RE: Farber Building Reno – Audio Visual, EN2401 – Request for information

**Subject:** AVI-SPL LLC / RFI-001 for Farber Building Renovations Audio Visual EN2401  
RFI #1

RFI # 3

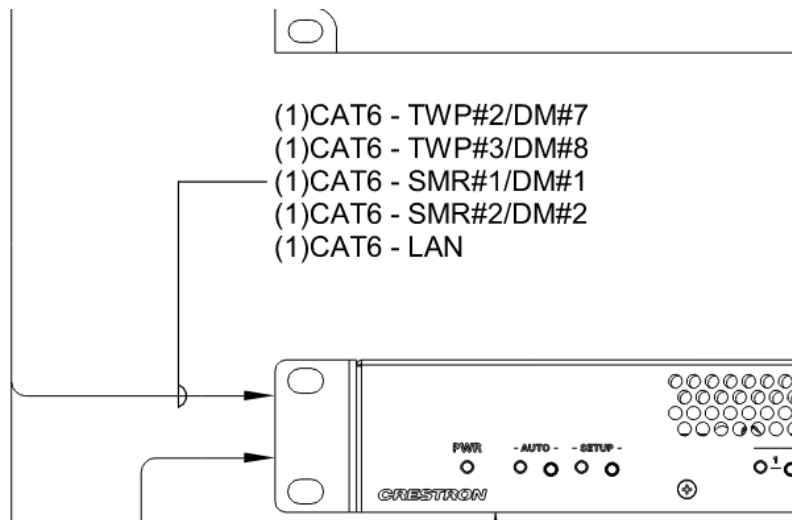
1. LV - 2.01
  - a. System shows all transmitters and receivers going through a network switch. That's not how the products you have specified in work  
**RGD: That's actually not what is shown on this drawing. All CAT6 from TX/RX go to a patch panel. A patch cord connects each TX/RX from the patch panel to one of the HD presentation switchers. See screen shot below that calls this out:**

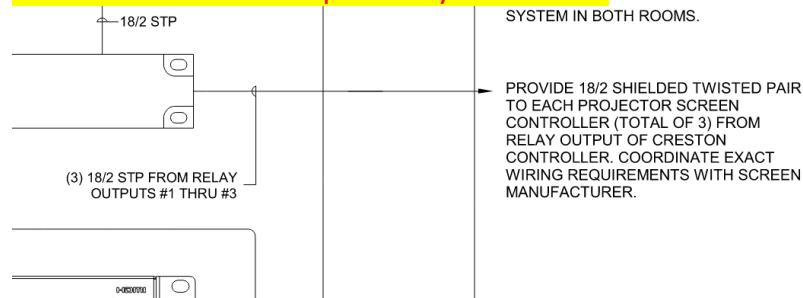
- b. There are no requests for Projection Screens. Will these be furnished by the owner? If so, what model number and manufacturer. Will the screens be controlled from the Crestron system?

RGD. REG to specify screens. Please read this drawing more carefully. There is a note that calls this out specifically. See below:
